TO: Mayor Keisha Lance Bottoms
ATTN TO: Monique Forte, Urban Planner III
FROM: Douglas R. Hooker, Executive Director
RE: Development of Regional Impact (DRI) Review

Name of Proposal: Chosewood Development (DRI #3206)

DRI #3206

CHOSEWOOD DEVELOPMENT DRI
City of Atlanta
Natural Resources Group Comments
November 19, 2020

DRI SITE PLAN

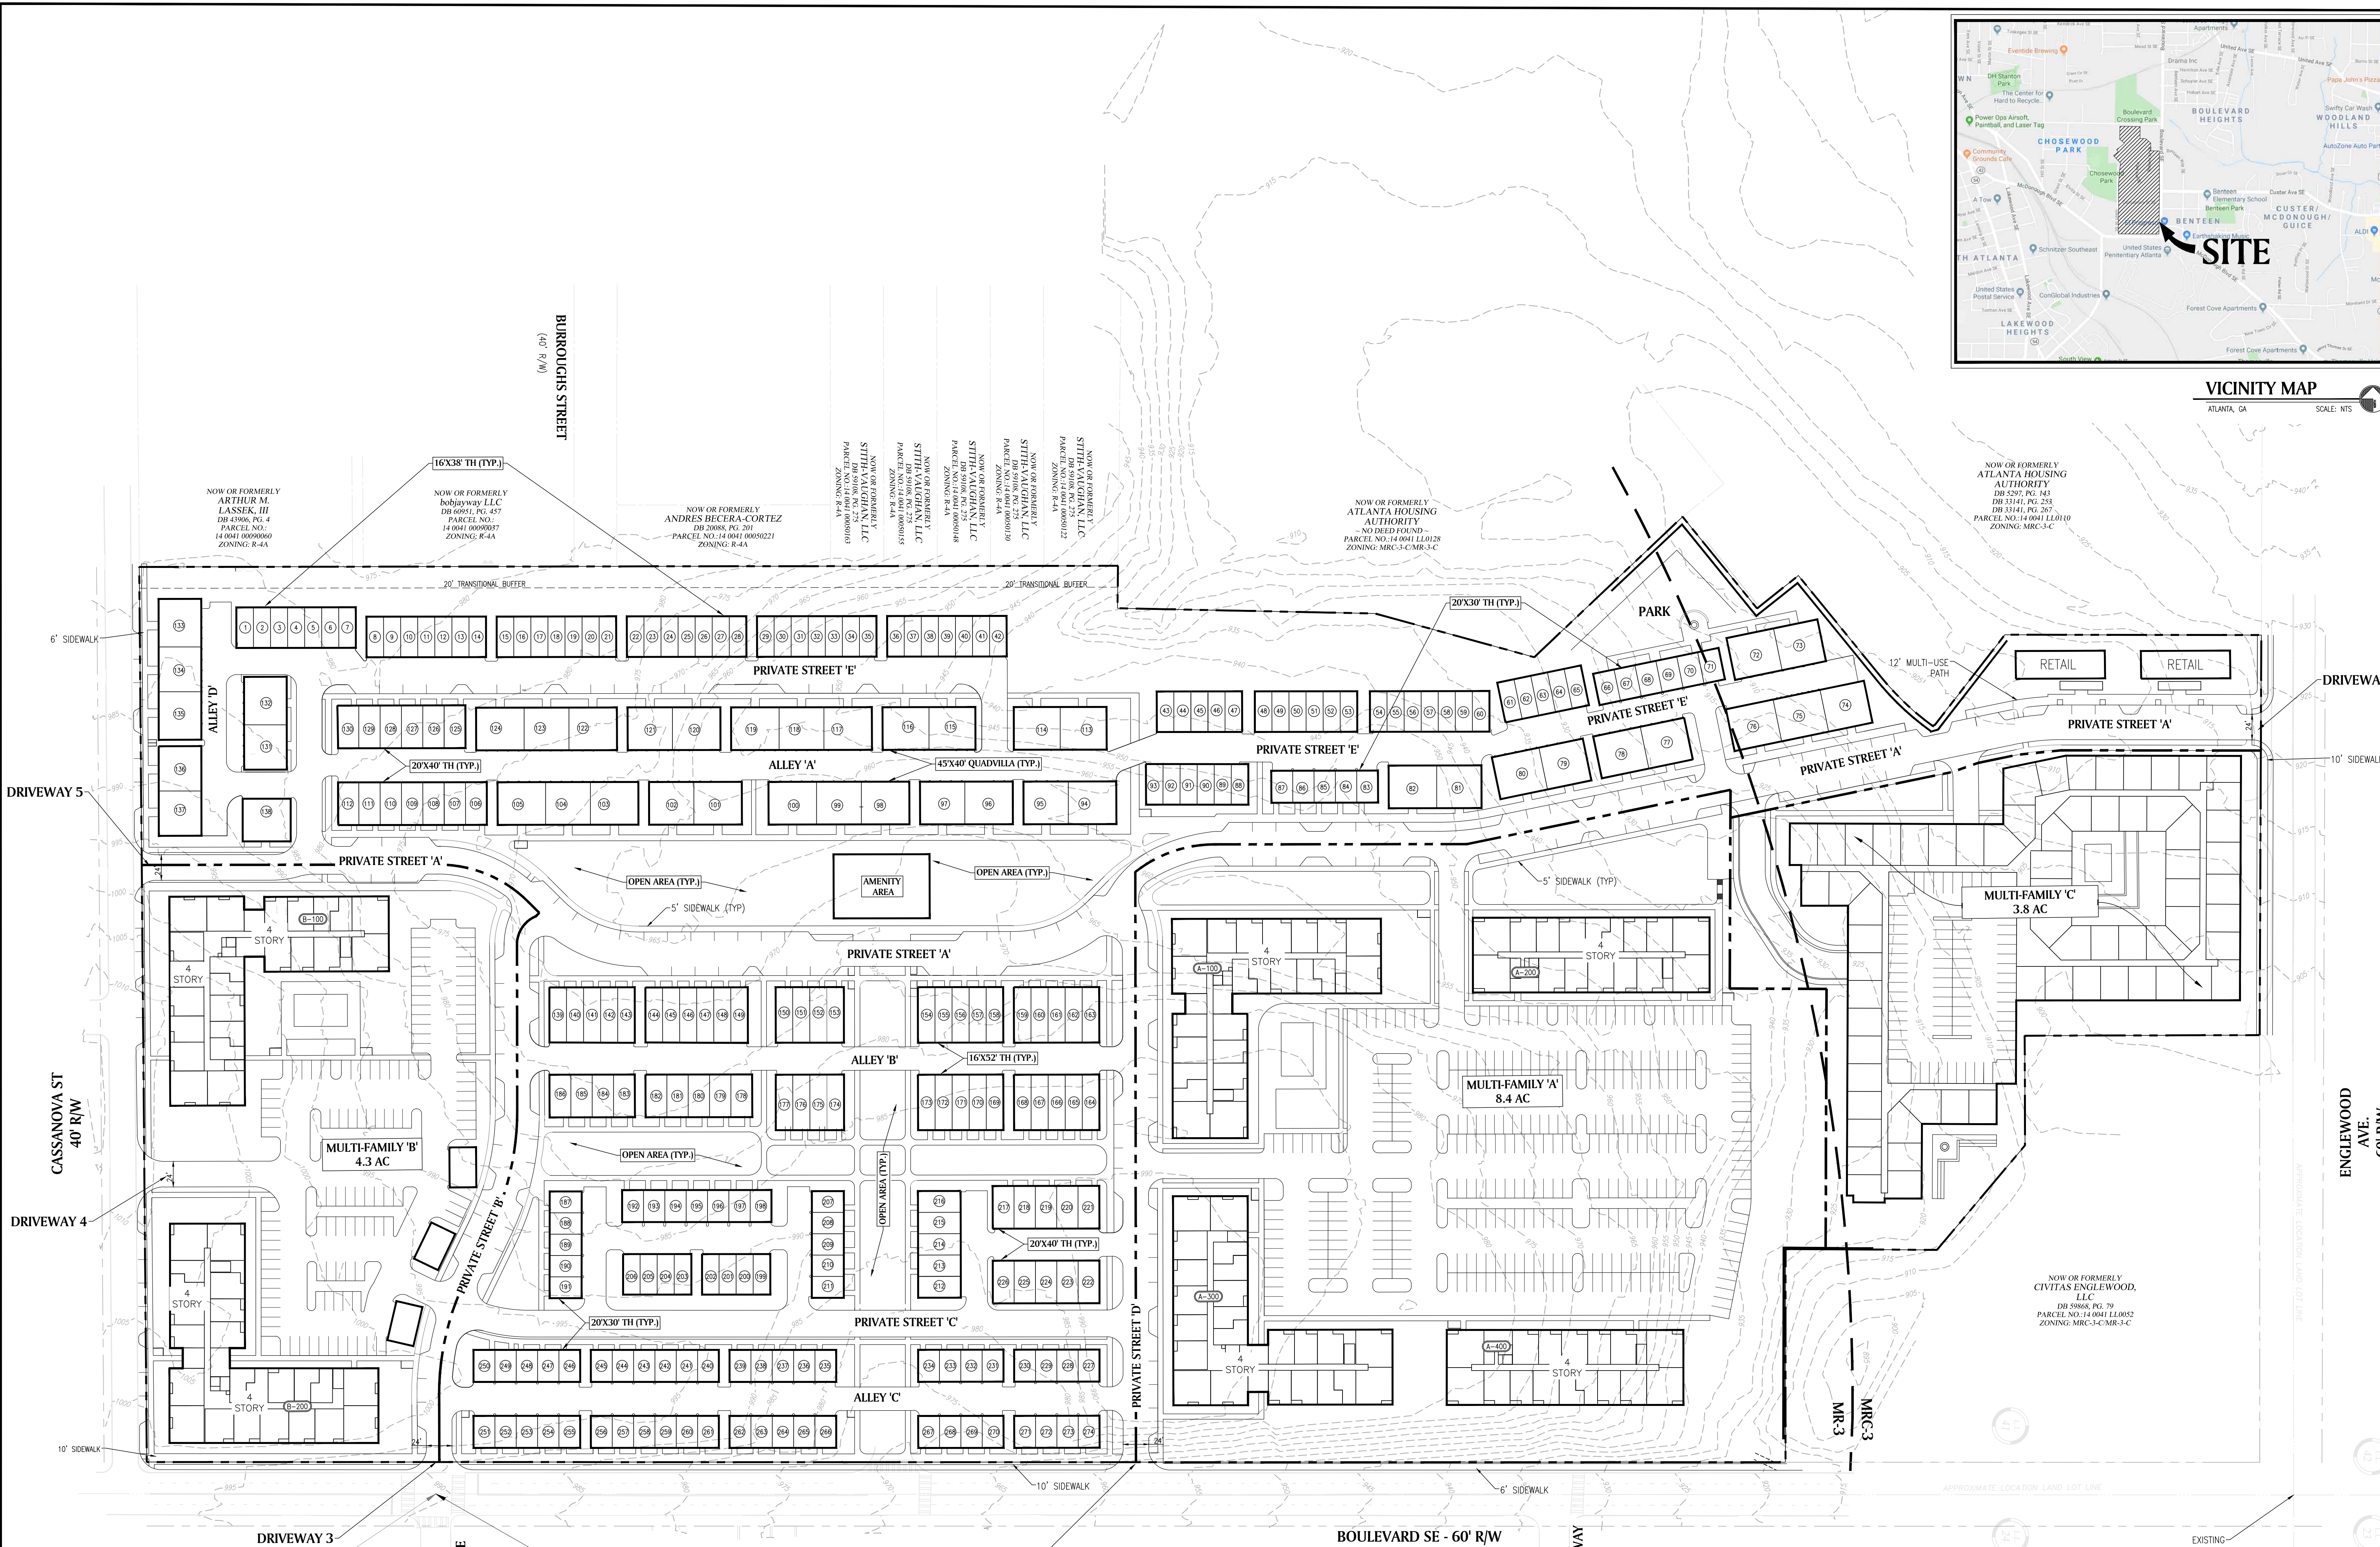
Concerns were raised during the Pre-Review Meeting for this project about the lack of a connection to the existing Burroughs Street in the southwestern corner of the DRI site. This street connection currently exists, but it was gated off to both drivers and pedestrians. The DRI as proposed would permanently preclude making this street connection in the future, which violates both the City's and the BeltLine's stated long-term goals of restoring and expanding the street grid. GRTA's Notice of Decision for the project is requiring a sidewalk connection between the DRI and the stub of Burroughs Street, and it should remain fully accessible to the public at all times.

The site plan does incorporate the potential for a future connection to the adjacent Englewood property at the northwestern corner of the site. This future street connection is also listed in the Atlanta Transportation Plan and the proposed BeltLine Subarea 3 Master Plan update. Another missed opportunity is the lack of an east-west pedestrian connection on Boulevard anywhere between Private Street D on the site plan and Englewood Avenue, along the northern edge of the Multi-Family A section. This has the effect of maintaining the existing "superblock."

is compatible with existing neighborhoods. The DRI's building heights transition downward as the site approaches the western edge of the property, which makes it more compatible with the existing single-family homes. The proposed density also appears compatible with the proposed future land use in the existing BeltLine Subarea 3 Master Plan and its pending update. The plan update has not yet been formally adopted into the City's Comprehensive Development Plan.

Neither the submitted site plan nor the USGS coverage for the project area show any streams on the property. Any unmapped streams on the property may be subject to buffers required under the City of Atlanta Stream Buffer Ordinance. Any unmapped streams and waters of the state on the property are also subject to the State 25-foot Erosion and Sediment Control Buffer.

Develop and construction of roads/drive aisle could potentially be restricted to the west of the project site due to the Chosewood Park. The project proposes to incorporate public access to adjacent streets and internal connectivity between some of the parcels via walking and biking.
